Subject: **Bid No. 8024-W3, Floor Upgrade – DCU Convention Center / DPF**

ADDENDUM NO. 2

- **PLEASE SEE BELOW QUESTIONS RECEIVED AND RESPONSES FROM CITY**

DCU CONVENTION CENTER
CORE PLAN
SSK-001A

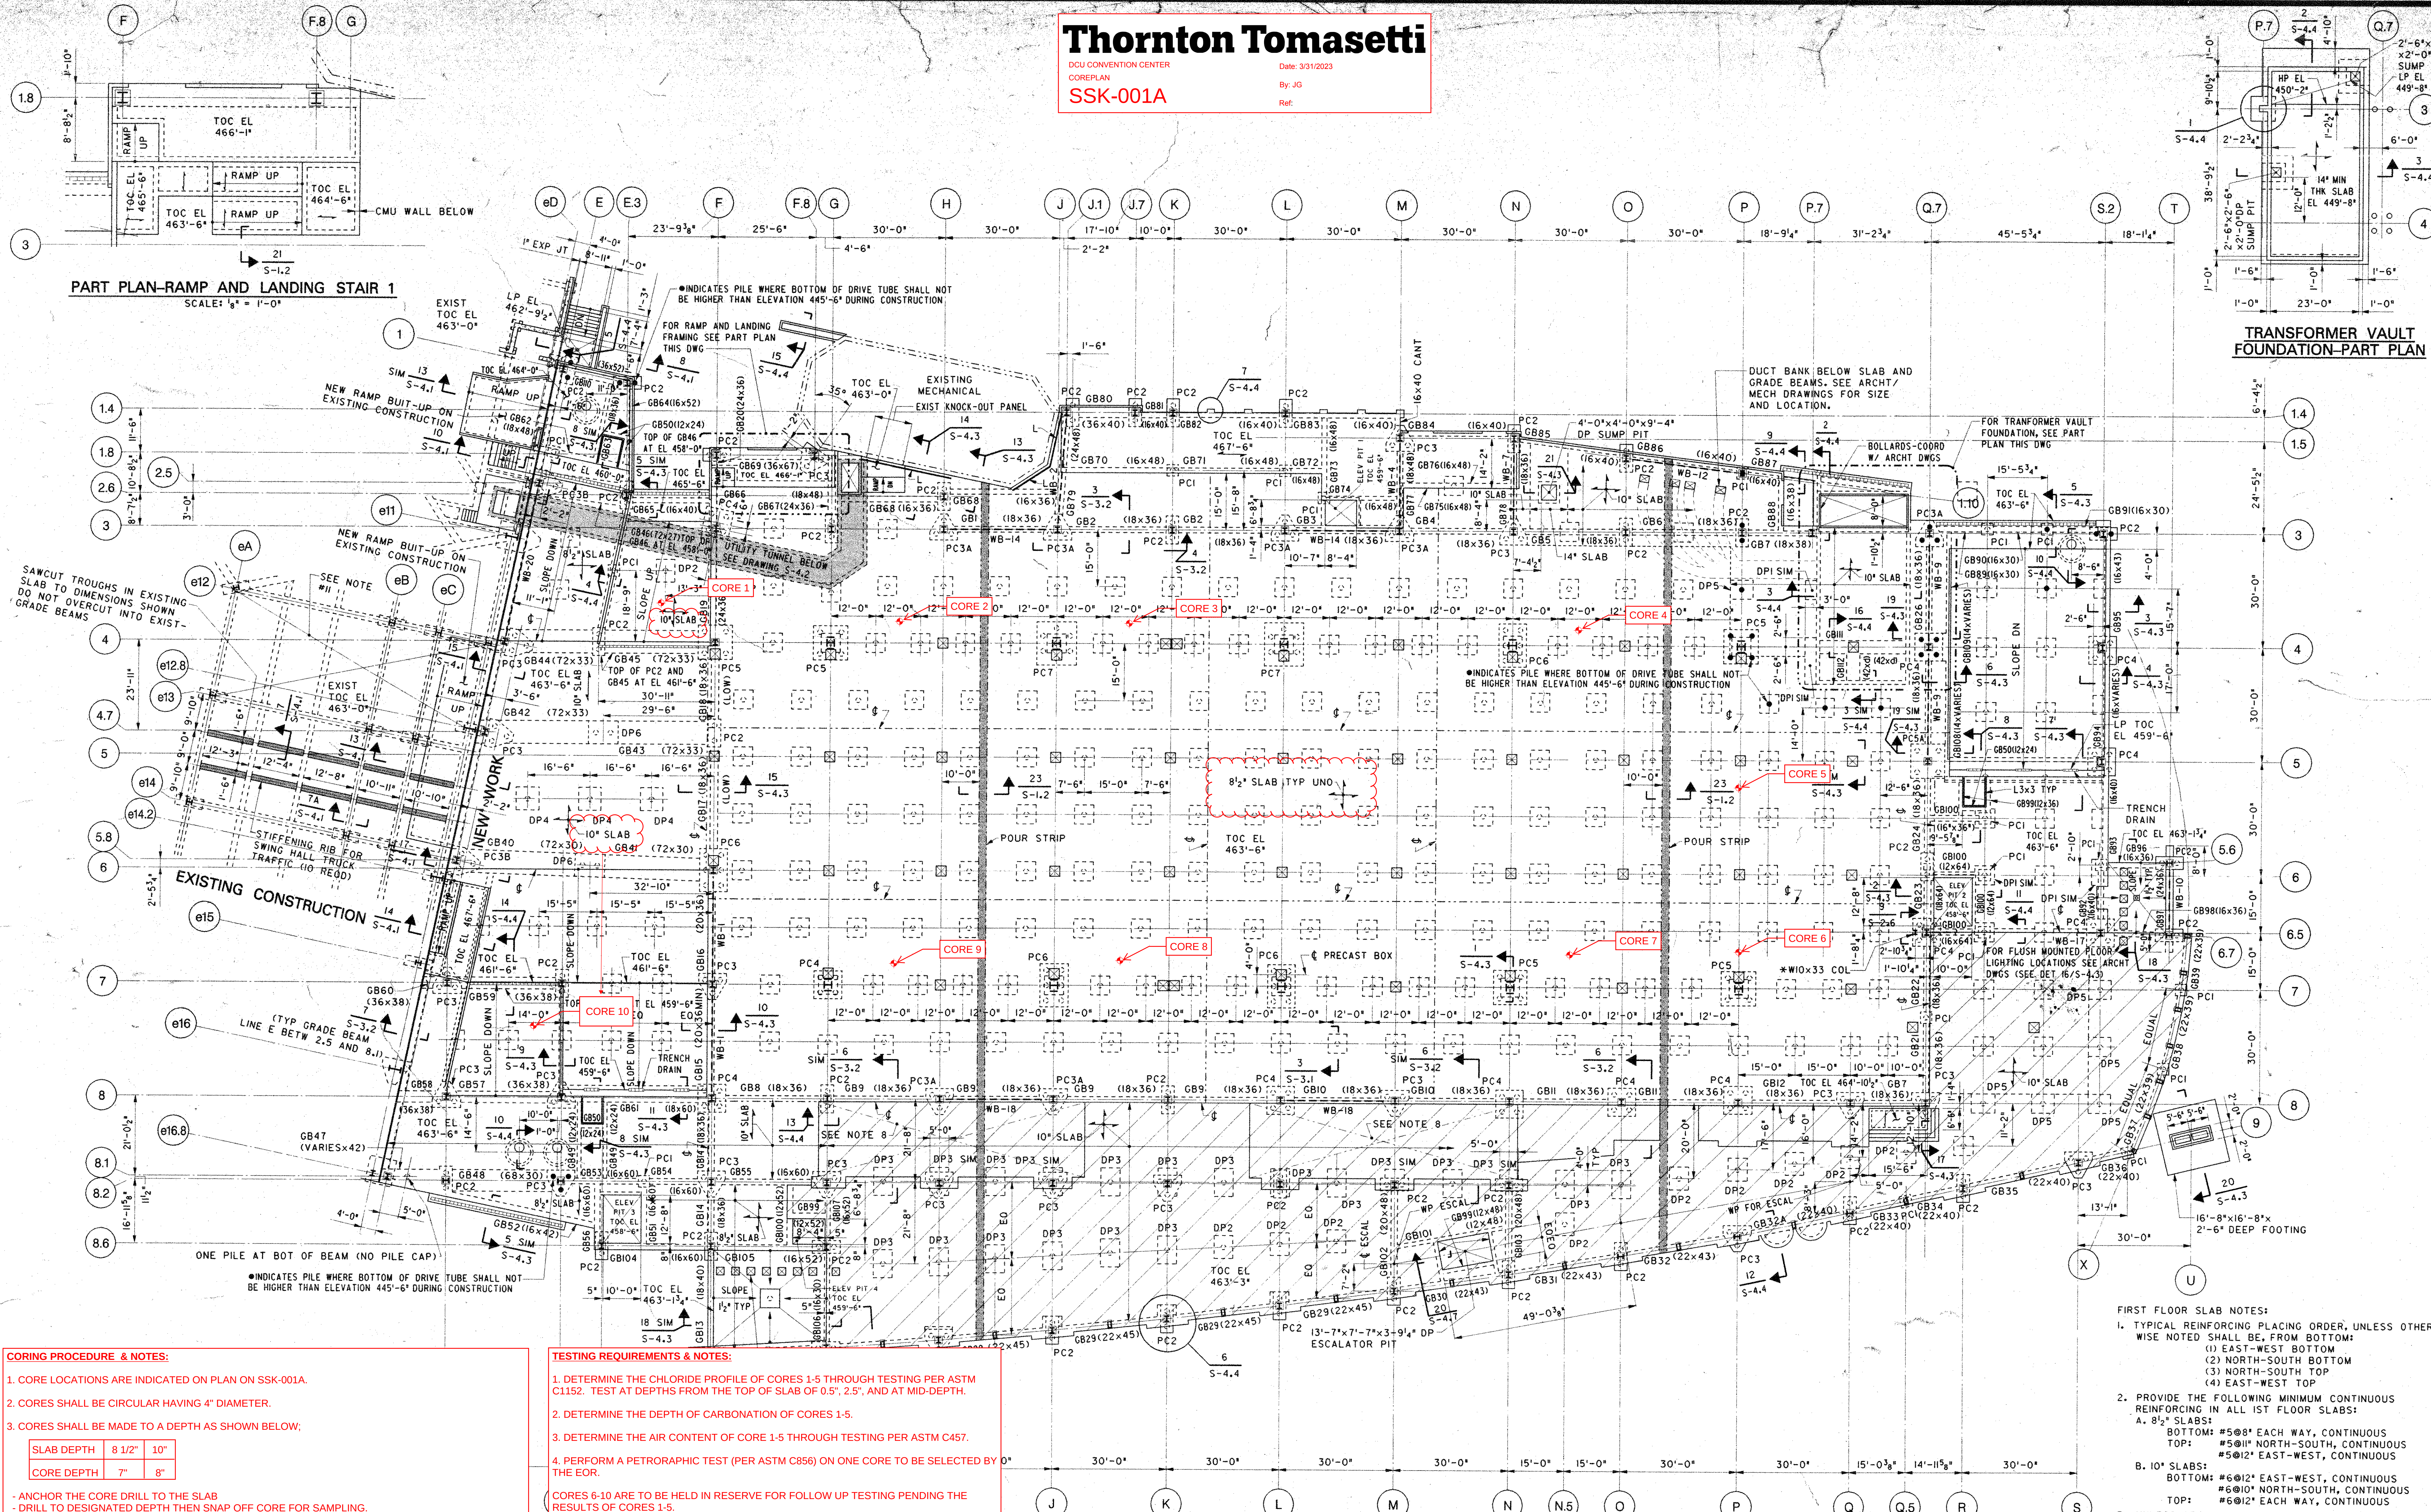
At the pre-bid conference, it was indicated that coring samples of the existing slab were obtained. Please provide the coring results if available.

Please see attachment.
